Request for Review

Please find below the response to the request for review formulated for the CDM project with the registration number 1375. In case you have any further inquiries please let us know as we kindly assist you.

Response to the CDM Executive Board

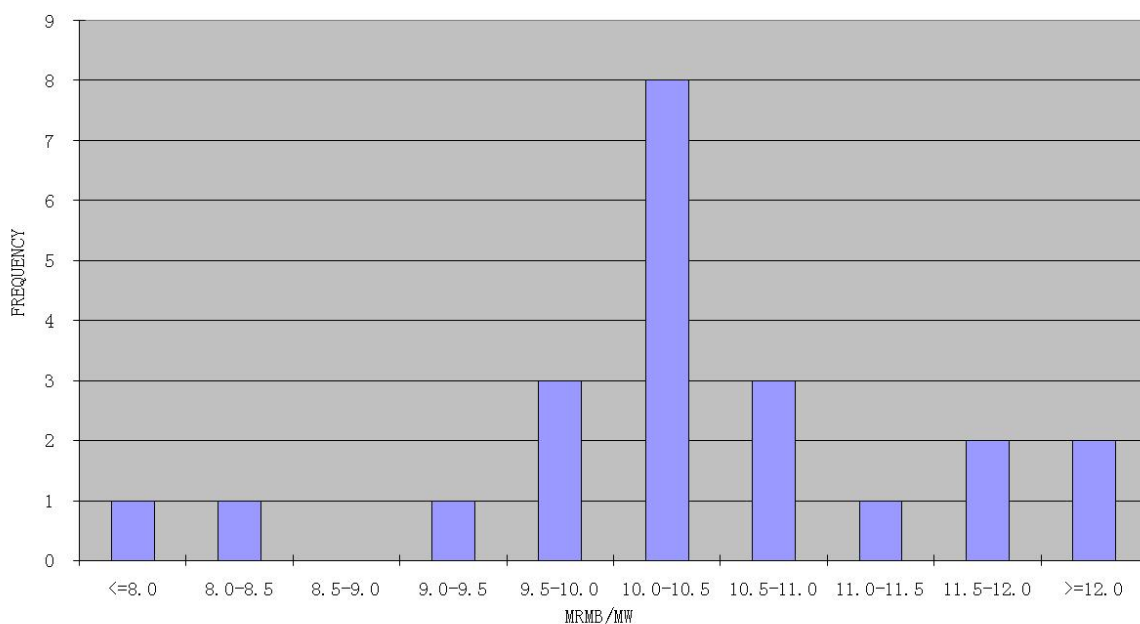
Further clarification is required on how all the input values of the investment analysis have been validated; in particular the sales revenue and the operating costs. In doing so it should be clarified why the expected revenues applied in the analysis are less than the revenue obtained using the tariff and net generation cited in the PDD.

About the project IRR calculation, we would like to clarify that all the detailed calculations submitted to the DOE have been validated. This process enabled to cross-check that the calculations actually use the input values cited in the PDD and that they are carried out accurately. In particular, the estimated annual revenue is correctly calculated and actually uses the tariff and the net generation cited in the PDD. For information, the detailed calculation of the estimated annual revenue is the following:

Nota: the calculated figures uploaded to CDM website were expressed in tens of thousands of RMB. The Electricity consumption rate for power generation accounts for the power consumption of the biomass plant itself. The above calculations are actually carried out correctly in accordance to the Chinese VAT system.

The IRR analysis has been verified by cross-checking the figures used with the feasibility report. The feasibility report has been approved by the Chinese authorities (see ref. 7 of the annex 2 of the validation report). Hence, no further investigation needs to be accomplished. The calculation has been checked as well. No mistake has been found.
